**Re: Portland Limestone Quarry - File No. M-1977-344;  
Preliminary Adequacy Review for 112 Construction Materials Reclamation Permit  
Amendment Application (AM-2)**

The Division of Reclamation, Mining and Safety (DRMS) has completed its preliminary adequacy review of your 112 Construction Materials Reclamation Permit Amendment Application (AM-2) for the Portland Limestone Quarry, Permit No. M-1977-344. The application was received on October 3, 2023 and called complete for review on October 10, 2023. **The decision date for this application is January 8, 2024.** Please be advised that if you are unable to satisfactorily address any concerns identified in this review before the decision date, **it will be your responsibility to request an extension of the review period.** If there are outstanding issues that have not been adequately addressed prior to the end of the review period, and no extension has been requested, the DRMS may deny this application.

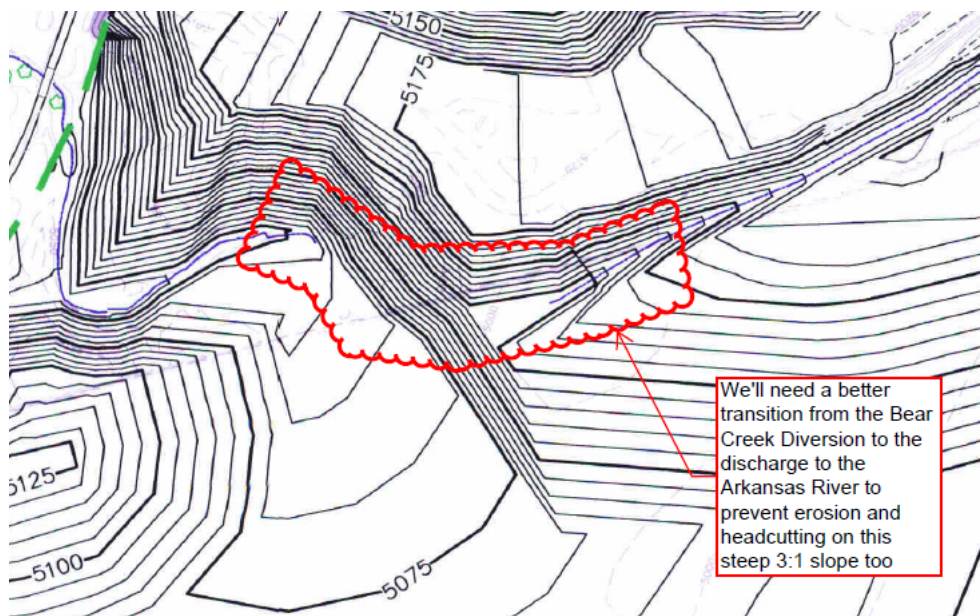
16. Salvaged Growth Material: The second paragraph on p. 47 states plant growth material will be salvaged and stockpiled in the bottom lift of a two-lift stockpile, and that overburden will be stockpiled on top of the growth media. Rule 3.1.9 requires growth media be segregated for other spoil. Placing overburden on top of growth media will make it difficult to distinguish between the two over a period of time. Please commit to stockpiling the two materials separately (side-by-side would be acceptable if the growth media is labeled with signage).
